GOVERNMENT OF THE DISTRICT OF COLUMBIA
DEPARTMENT OF CONSUMER AND REGULATORY AFFAIRS
OFFICE OF THE ZONING ADMINISTRATOR

Re: Zoning PDRM – 2012 Kalorama Road, NW – Subject Property

ZONING ANALYSIS 2012 KALORAMA RD, NW

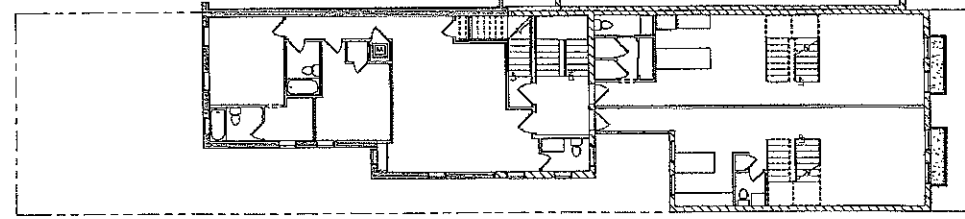
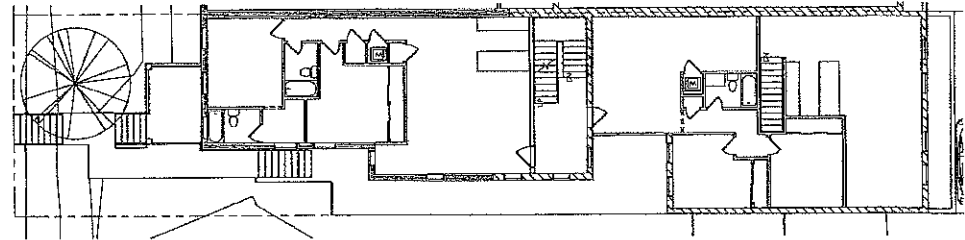
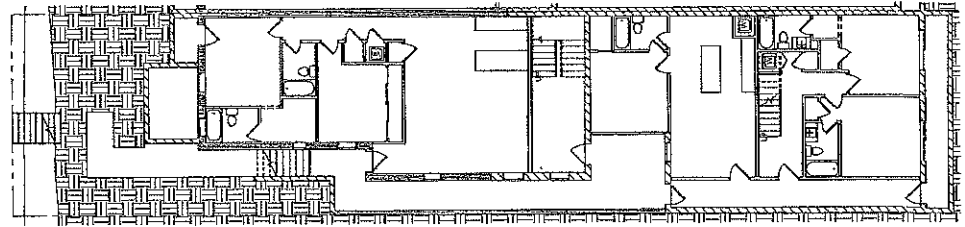
- 6 - The open courtyard which is surrounded by walls on three sides will extend from the lowest level up thru the roof and will be open to the sky. The courtyard is to be a minimum of 10'-0" in either direction and will be considered a legal open court.

7 – The existing non-conforming side yard will be eliminated through the introduction of a conforming open court at the termination of the side yard.

8 – The areaway leading to the open court and the open court itself shall not be used in the calculation of lot coverage.

01 CELLAR ZONING
10' x 10'

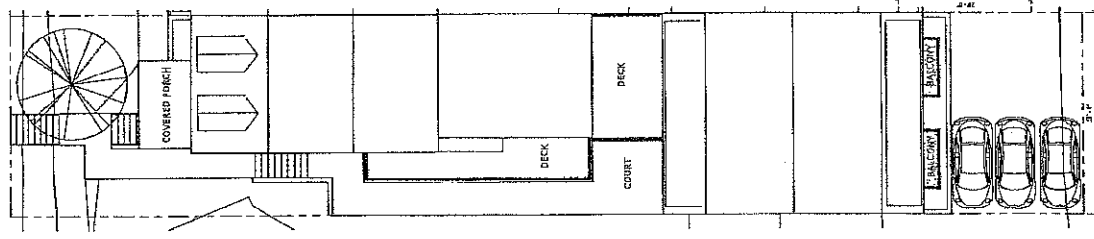
- 3 - The lowest level of the building shall be determined to be a basement or a cellar based on the difference between the top of the adjacent grade and the surface of the ceiling at that level. If this dimension is less than 4', or the 2'-5" that is proposed, it will be deemed to be a cellar. In the case of a limited areaway to access the level, the top of the grade adjacent to the areaway shall be used.

- 4 - The FAR calculation for the building exempts a cellar from the calculation; The cellar will not be counted towards the F.A.R. of the building.
- 5 - The existing parking spaces of the building will be maintained and will be grand-fathered into the proposed building. Proposed parking will maintain the existing three parking spaces at the rear of the building and off of the public alleyway and will provide a total of three parking spaces for the entire building and are to be maintained at their current location and configuration. The dimensions of these spaces shall maintain the minimum dimensions in both directions.
